STAFF RECOMMENDATION
2014 White Avenue
October 16, 2019

Application: Partial Demolition; Alterations; New Construction—Addition
District: Woodland in Waverly Historic Preservation Zoning Overlay
Council District: 17
Base Zoning: R6
Map and Parcel Number: 10510033300
Applicant: Mitch Hodge
Project Lead: Melissa Baldock, melissa.baldock@nashville.gov

RENOVATIONS AND ADDITIONS
2014 WHITE AVE
NASHVILLE, TN 37204

Figure 4 (left) is an aerial view of the addition that will be removed. Figure 5 (right) is the c. 1968 footprint of the house from the Property Assessor's office; the addition does not exist in this

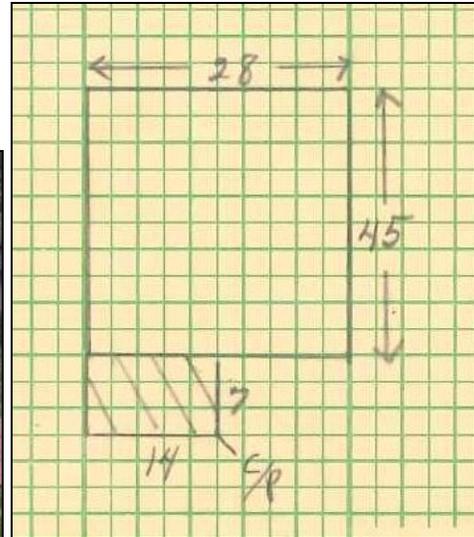
Partial Demolition: The applicant plans to remove an existing, non-historic addition (Figure 4). The footprint of the house shown on the c. 1968 Property Assessor card does not show this addition, so the addition was constructed after 1968 (Figure 5). Staff finds that it is not a significant part of the historic house and that its removal is appropriate.

Staff finds that the existing rear addition does not contribute to the architectural and historical character and significance of the house or the district, and that its demolition meets Section V.B.2 for appropriate demolition and does not meet section V.B.1 for inappropriate demolition.

Figures 6 & 7 are c. 1980s photos of the house that show window openings to be altered.

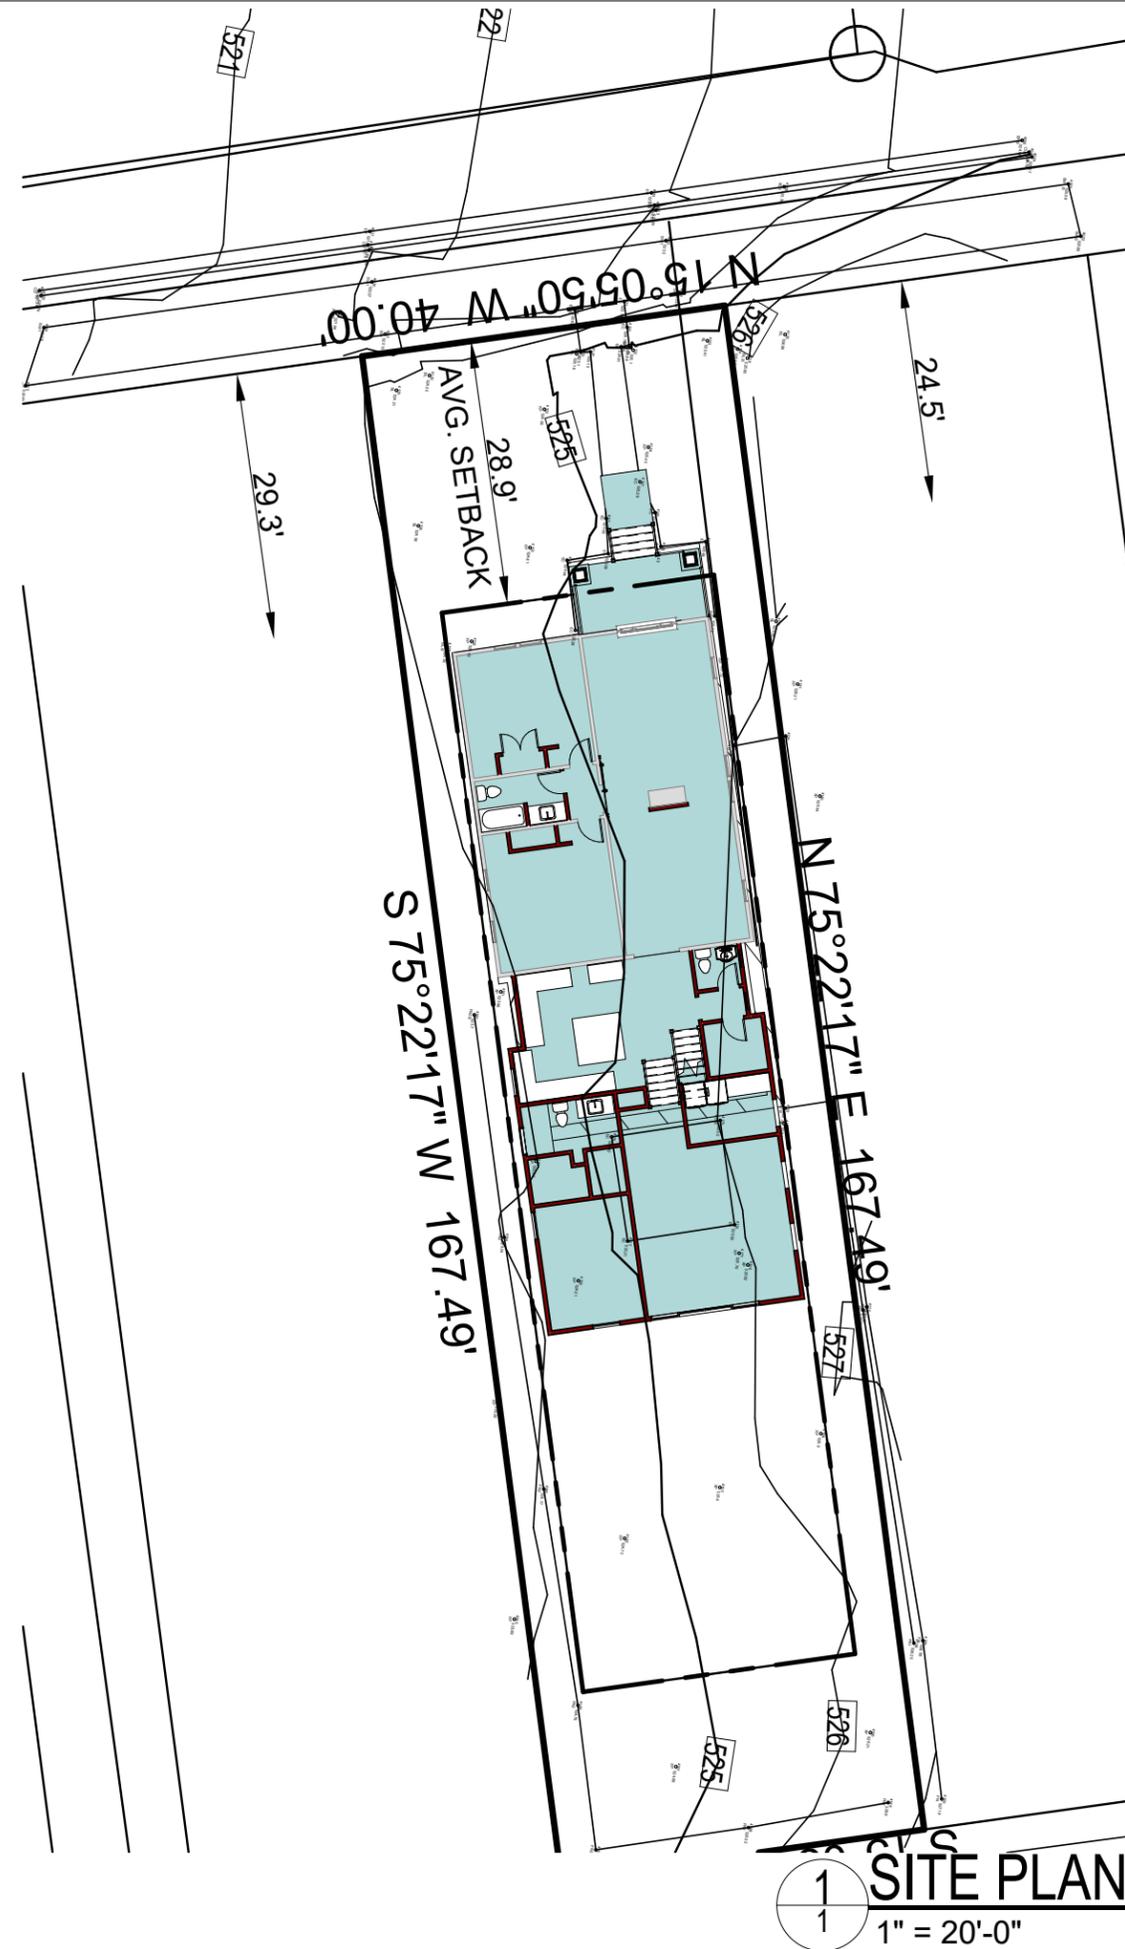
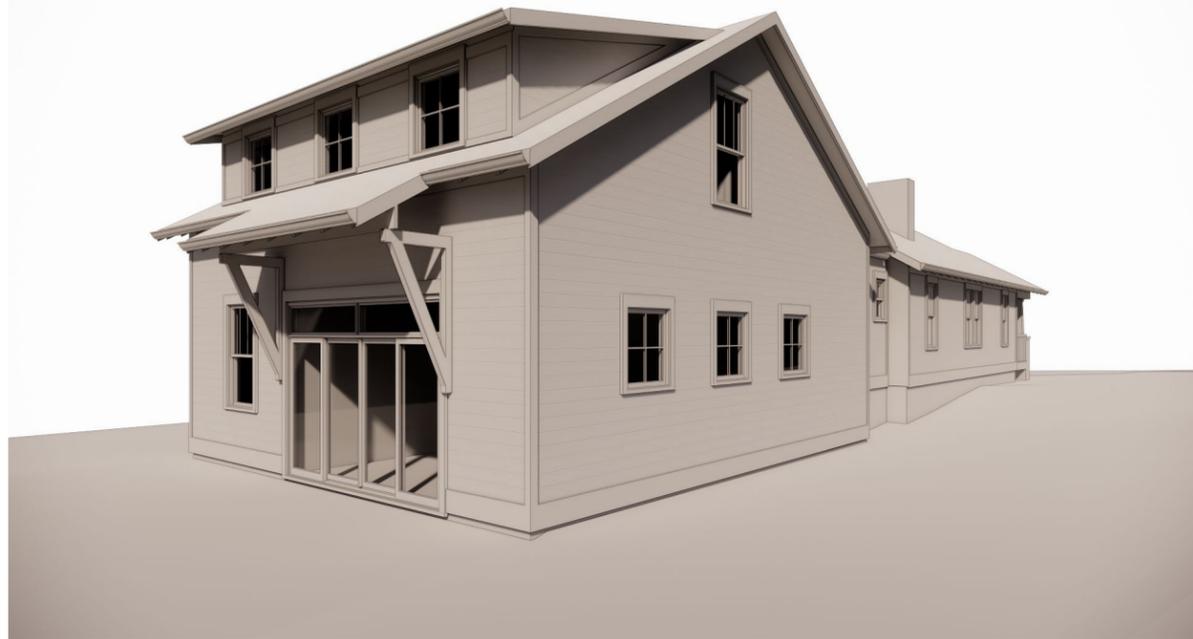
The applicant is proposing some alterations of window openings on the side façade. On the left side façade, the applicant proposes to enlarge an existing window opening to match the dimensions of other openings on the historic house (Figure 6). Staff finds that this alteration is appropriate, as the c. 1968 photo seems to show a larger window opening in that area (See Figure 2). In addition, the house next door at 2012 White Avenue has window that is the same size as what is proposed in this location.

On the right façade, the applicant is proposing to remove a window opening towards the back (Figure 7). Again, this window opening does not appear to be original, and its removal is appropriate. If when the siding is removed, evidence of other window openings is shown, staff will work with the applicant on restoring the historic window pattern.

With the condition that the applicant work with MHZC staff after the vinyl siding has been removed to assess the condition and potential retention or replacement of any historic materials and that the historic windows be retained, unless beyond repair, staff finds that the proposed alterations meet Section II.B. of the design guidelines.

ELEVATIONS

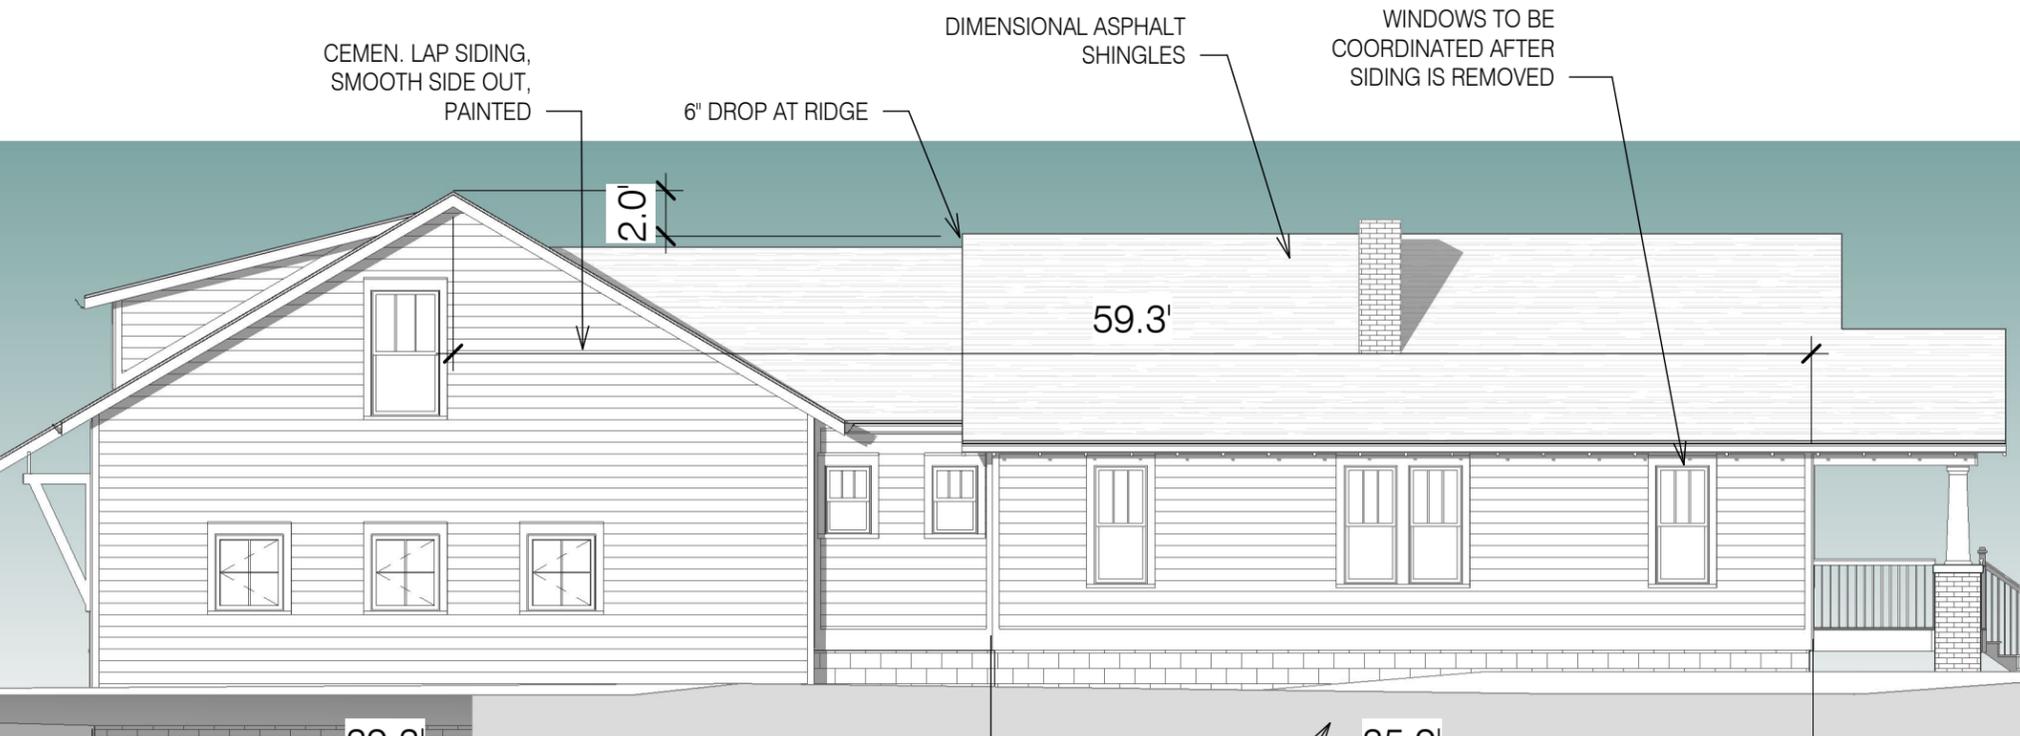
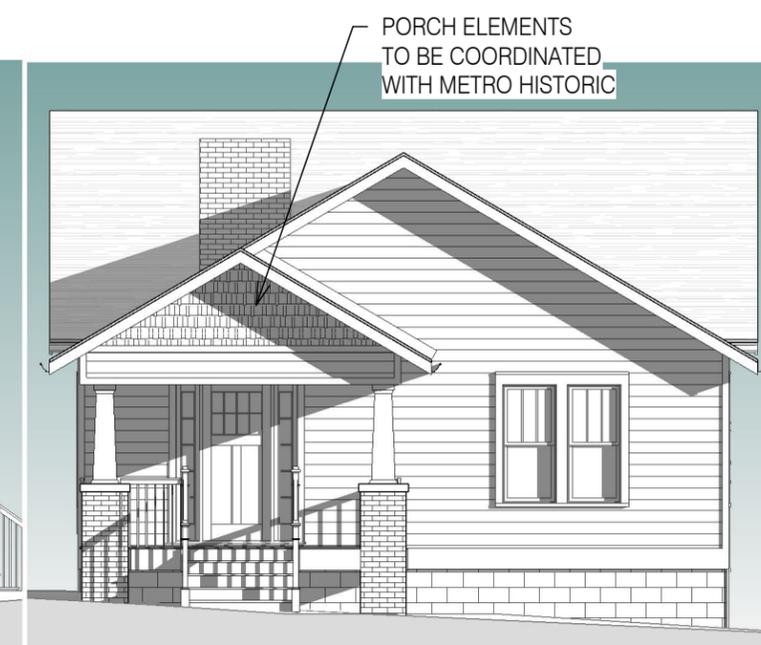
Height & Scale: The proposed addition ties into the historic house six inches (6') below the house's roof ridge, which is appropriate. It is inset one foot, six inches (1'6") from the back corners of the house, which is appropriate because the addition's maximum scale is one-and-a-half stories in height. After a depth of eight feet (8'), the addition steps back out to match the width of the historic house.

This back portion of the addition is two feet (2') taller than the historic house, which staff finds to meet the design guidelines. Typically, staff recommends that taller portions of an addition be inset two feet (2') from the back corners of the house, but staff finds that the taller portion that is not inset to be appropriate for several reasons. Although the addition's ridge is two feet (2') taller, its eave height is just one foot (1') taller. Located over forty feet (40') back from the front of the house, staff find that this extra height will not be highly visible from the street and will not negatively impact the historic house. In addition, the existing house is just twenty-eight feet (28') wide, which is narrower than many other historic houses in the area, and it sits on a narrow lot. The addition's extra height helps to add space to the historic house while keeping the footprint reasonable compared to the size of the historic house. After the demolition of the existing addition and the construction of the new addition, the house's footprint will increase from approximately one thousand, three hundred and sixty square feet (1,360 sq. ft.) to approximately two thousand, one hundred, and eighty-six square feet (2,186 sq. ft.).

Roof form: The addition ties into the house with a front-facing gable. The taller portion of the addition has a side-gable form with a pitch of approximately 8/12. The rear portion of the addition has a rear-facing dormer that is inset two feet (2’) from the side walls and two feet (2’) from the back wall of the addition. Staff finds that the addition’s roof forms are compatible with the historic house.

Proportion and Rhythm of Openings: The windows on the proposed addition are all generally twice as tall as they are wide, thereby meeting the historic proportions of openings. There are no large expanses of wall space without a window or door opening.

With staff’s final approval of the windows and doors and roof shingle color/texture for the addition, and with the condition that no changes be made to the historic house’s historic materials without staff’s approval, staff finds that the known materials meet Sections III.B.1. and III.B.2.d. of the design guidelines.

1. The applicant meet with MHZC staff after the vinyl siding has been removed to assess the condition of what historic materials remain and whether or not they are required to retain those materials;
2. The existing historic windows remain and be restored, if necessary, unless MHZC staff determines that they are beyond repair;

3. Staff approve the final details, dimensions and materials of windows and doors for the addition prior to purchase and installation;
4. Staff approve the roof color and masonry color, dimensions and texture; and
5. MHZC approve all appurtenances prior to purchase and installation, including, but not limited to, HVAC units, all utilities, lighting, railings, fencing, pathways, pavers, patios, and decks.
